1315 EAST JEFFERSON

DRB RECOMMENDATION MEETING

DPD #3014830 DECEMBER 4, 2013

FIG 05: View of Commercial Patios - Restaurant Use

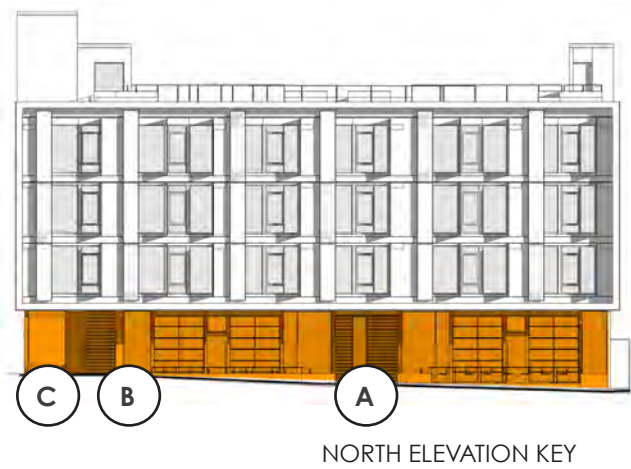
The Board was concerned about the viability of the ground level retail spaces setback from the E Jefferson Street sidewalk. The Board noted the street level setback should be designed to support active retail spaces that engage with the sidewalk. The Board requested street level vignettes demonstrating treatment of the ground level at the Recommendation Meeting (D-1, D-9, D-10, D-11).

RESPONSE: To support active retail spaces, we have included two outdoor patios on either side of the main retail entry area that will support the retail tenants. These spaces will provide opportunities for retail activity to engage and activate the streetscape. In addition, the majority of the retail façade has operable doors, creating a permeable barrier that brings indoor activity to the sidewalk and street.

(See **FIG 05,06,07** for an illustration of the patio use, as adapted to a variety of potential tenants.)

FIG 09: Planting Sun Access Diagram

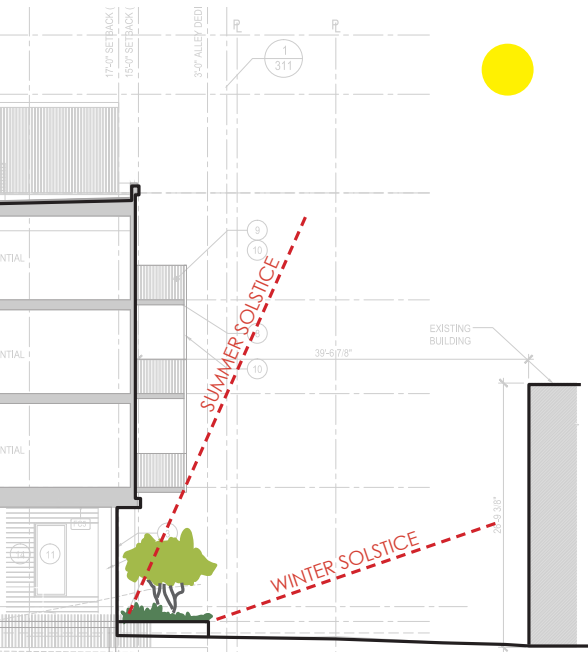
The Board was supportive of the landscaping proposed along the alley, which contributes to the alley's residential character. At Recommendation, the Board requested a landscape plan demonstrating the viability of the proposed plants under the shaded building cantilever (D-8, E-1 and E-2).

As indicated in the building and landscape plans, the cantilever is very shallow over the planted area. This combined with the 13'-6" high clearance ensures that the plants will receive ample light (see FIG 09).

FIG 10: Alley Elevation

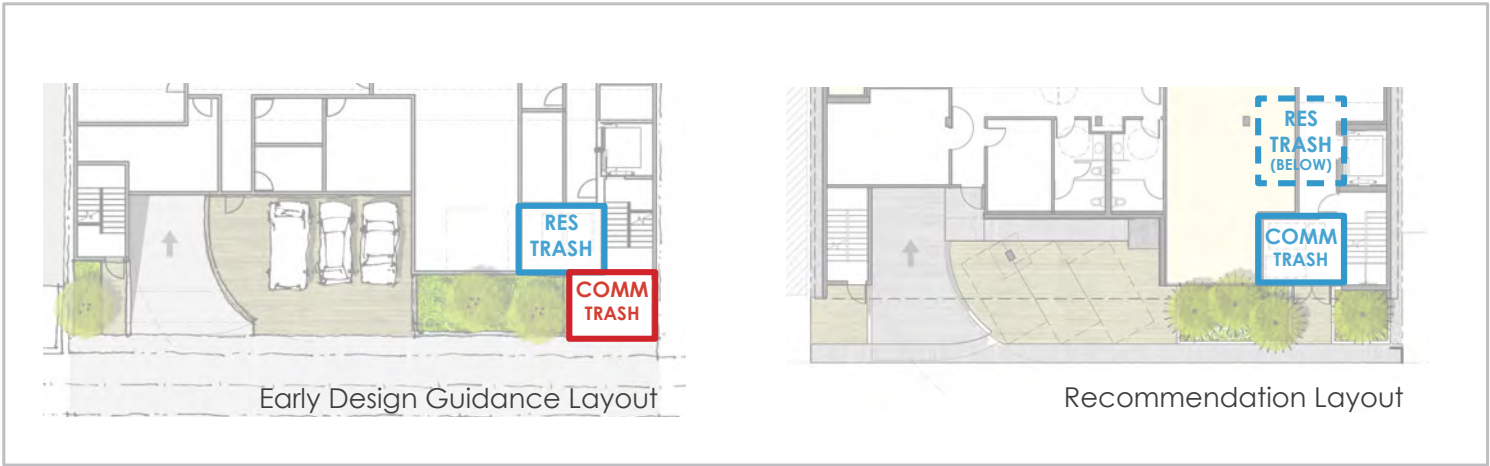
The Board requested more information about the location of trash and recycling space entrance at the Recommendation meeting (D-6 and D-8).

The commercial trash access is located between the South retail space and the east stair. The residential trash is located in the garage and will be brought up on trash collection day. The residential trash staging is at the southwest corner of the building to maintain separation from the retail/landscaping. The containers will be placed back in the garage once the collection has been made, maintaining a clean alley façade free of odors. (see FIG 10,11)

FIG 12: Fenestration Overlay

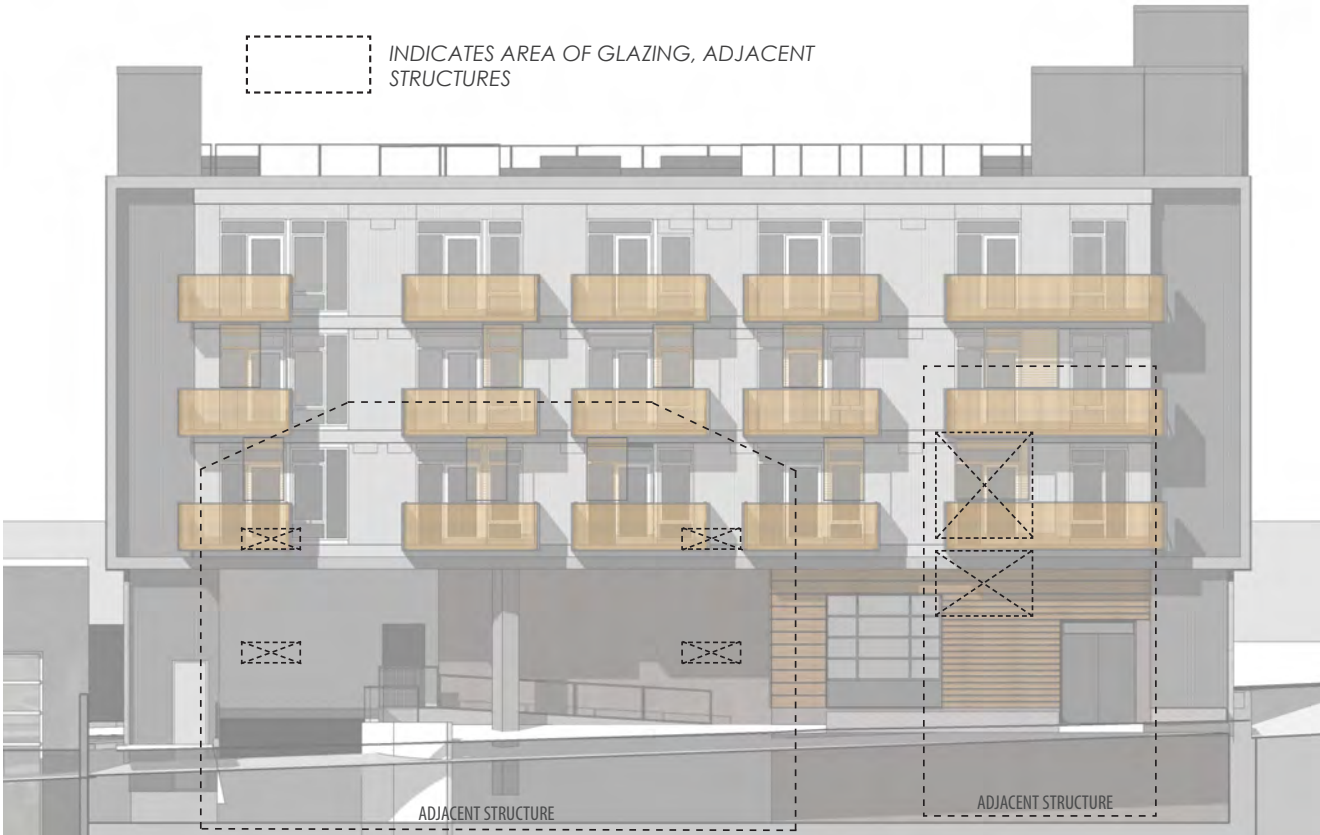
The Board requested the applicant provide a privacy study including the location of windows and outdoor space for adjacent residential structures across the alley. The applicant will need to demonstrate how the architectural concept, window glazing and deck location mitigate privacy concerns for adjacent residential structures (A-5 and C-2).

We have one particular privacy concern along the alley in regards to the townhouse adjacent to the east end of our building. We have been in contact with the residents and were provided access to their home to study the existing conditions. We used this information to place our screens along the alley in such a manner as to address their privacy concerns while still maintaining access to light for the tenants in the adjacent units. The area of the adjacent townhouse glazing is illustrated on our south elevation. (see FIG 12 & Page 42)

FIG 13: Alley Section

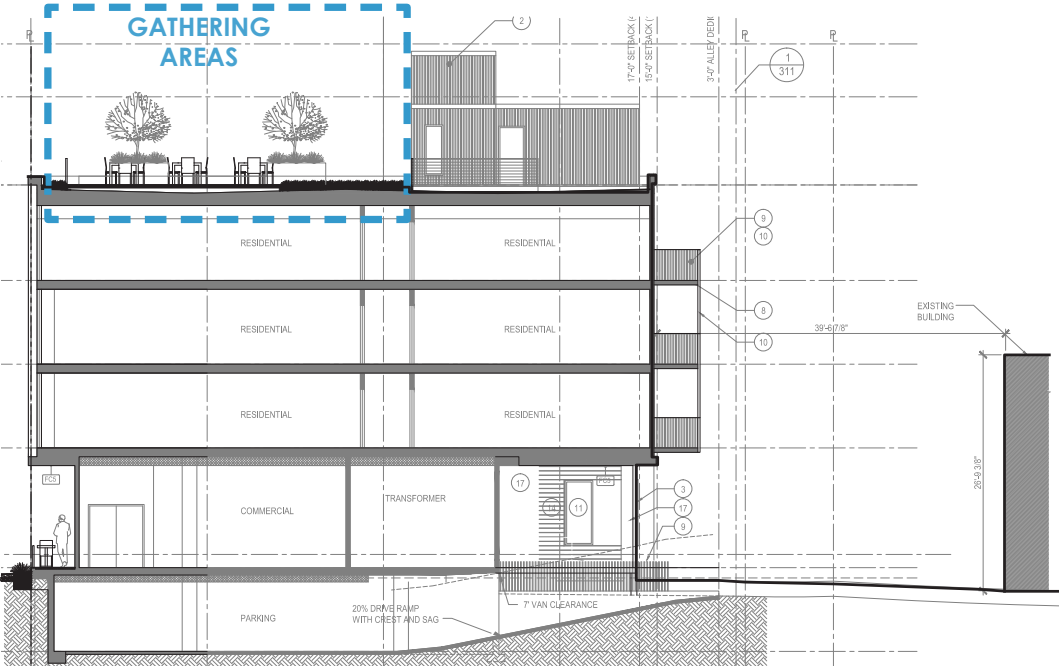
BOARD GUIDANCE:
The Board encouraged the applicant to concentrate active roof deck area toward the street façade to mitigate privacy impacts to residential units across the alley (A-5 and A-7).

RESPONSE:
Designated areas of activity on the roof deck have been focused towards Jefferson Ave. At no point will an occupant of the roof deck be able to look over the structures in the alley, ensuring privacy for our neighbors. (see FIG 13)

1. SETBACK REQUIREMENTS
(SMC 23.47A.014 B3)

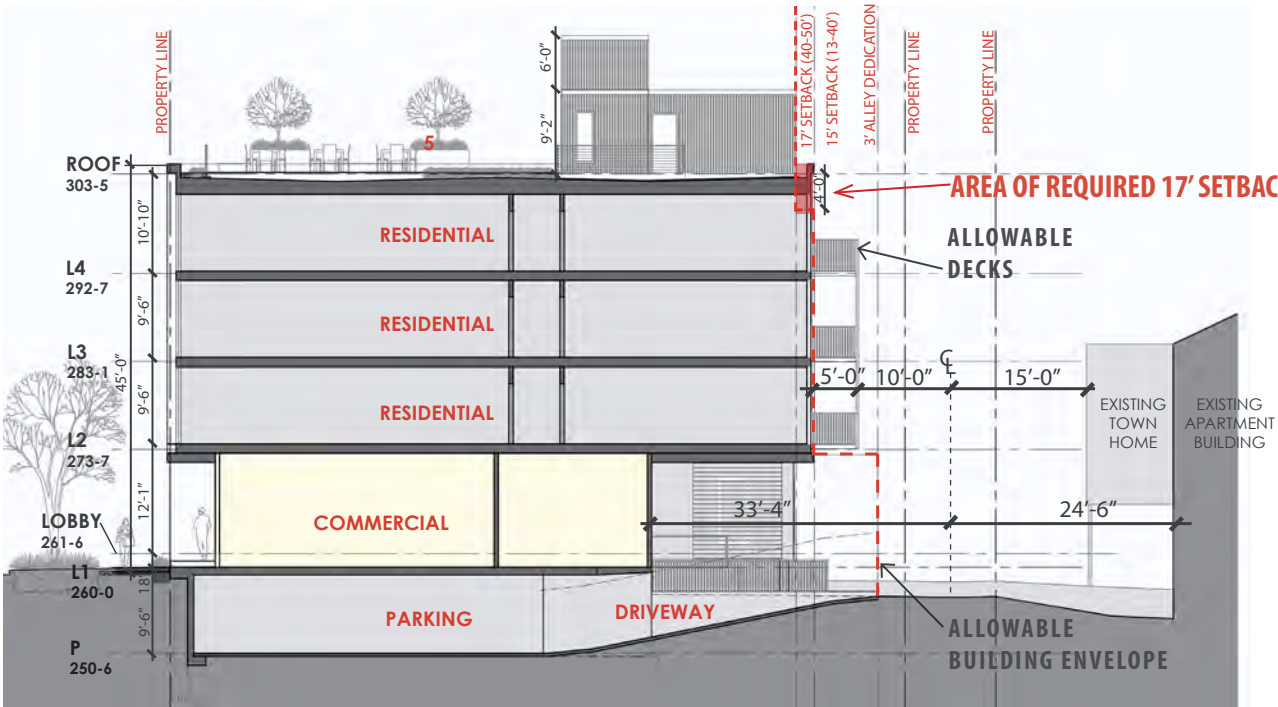
Request:
Allow the upper portion of the alley facade between 40’ and 44’ (for 4’ vertical feet) to continue at the 15’ setback.

Rationale:
The departure allows us to maintain a consistent facade plane along the alley rather than stepping the 4th floor back 2’. This allows the upper residential portion of the south facade to maintain a clean, simple massing consistent with the adjacent building facades along the alley and in our neighborhood.

The Board was inclined to support this departure at the EDG meeting.

2. PARKING SCREENING
(SMC 23.47A.032 G)

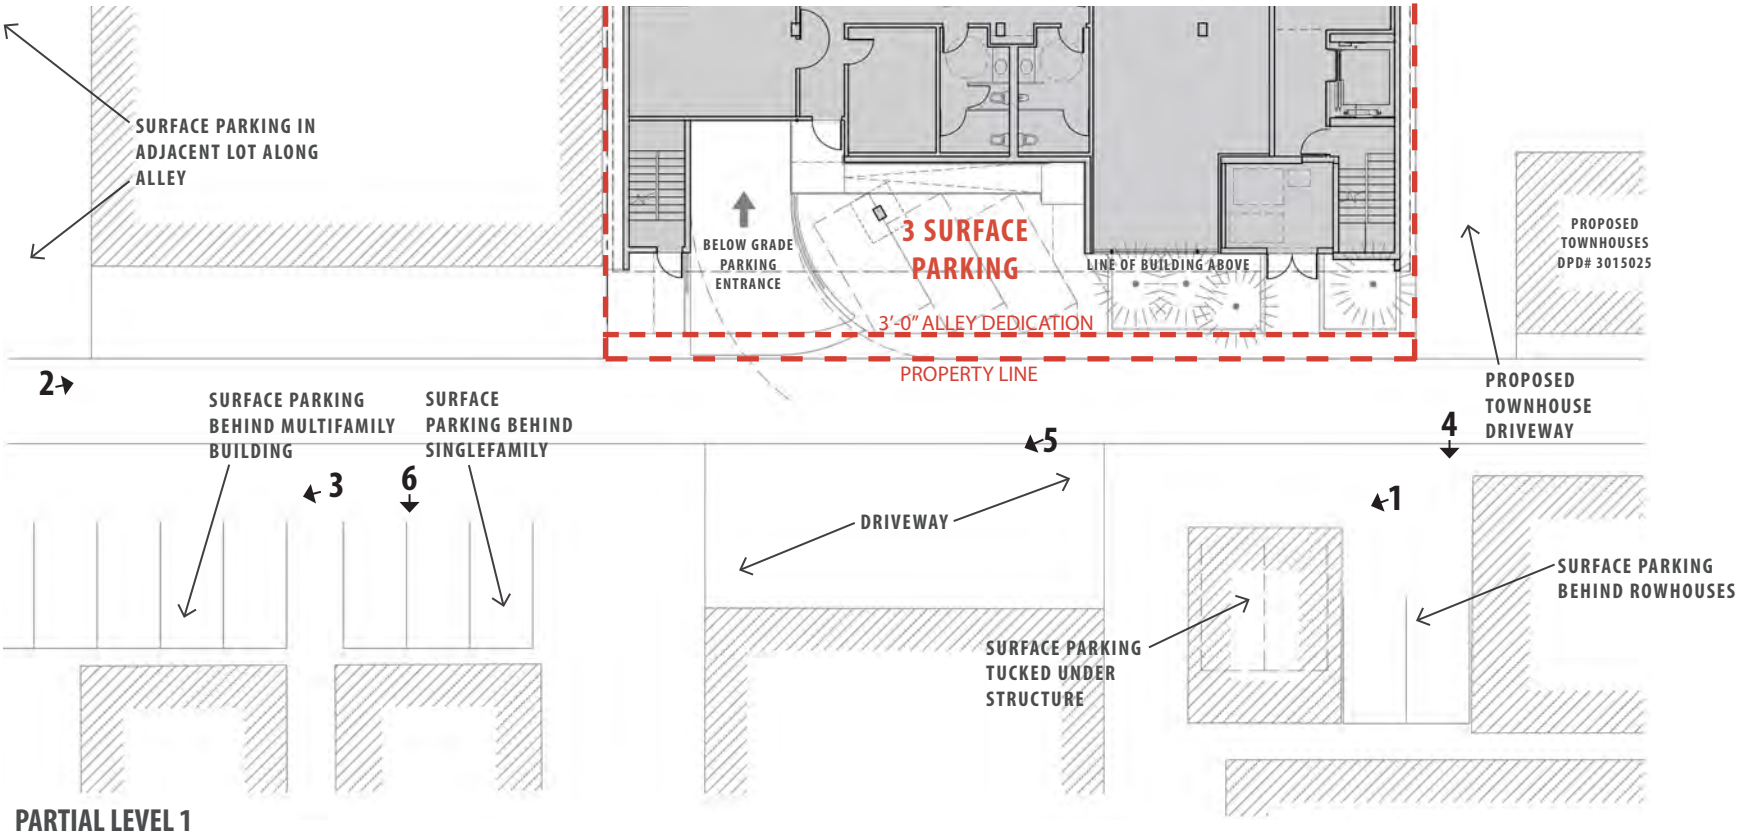
Request:
Allow for no landscape buffer for alley parking.

Rationale:
Considering the established precedent of surface parking along both sides of the alley adjacent to our site and in an effort to help alleviate the parking demand in the neighborhood, we are requesting a departure to allow 3 parking spaces accessed directly from the alley.

At the EDG, the board was inclined to support the departure provided the alley programmed utility spaces are minimized to the area of the parking with the remainder being landscaping and other treatments supportive of the residential character of the alley. As described and illustrated in an earlier section in the packet (pages 39-40), we have reorganized the programmatic functions to limit the utility functions to the parking/driveway area, and emphasized the residential character of the neighborhood with the landscape, hardscape and warm material treatments at the east end of the facade.
